Product Change Notification

End of Life Notification

PCN Number : PCN130

Product Category : Surface Mount PTC Resettable Fuse.

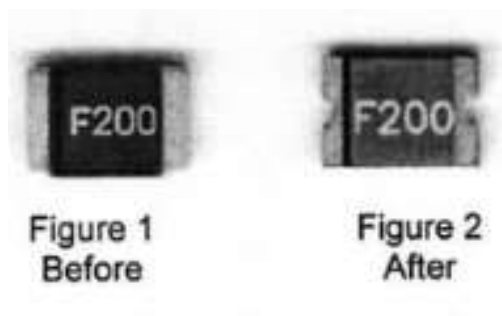
Reason For Change : The Terminal Appearance has been changed from Figure 1 to Figure 2 to improve the solderability. The change has been made to 0805, 1206, 1210 & 2920 footprint. This change has no effect on the Electrical / Mechanical / environmental performance.
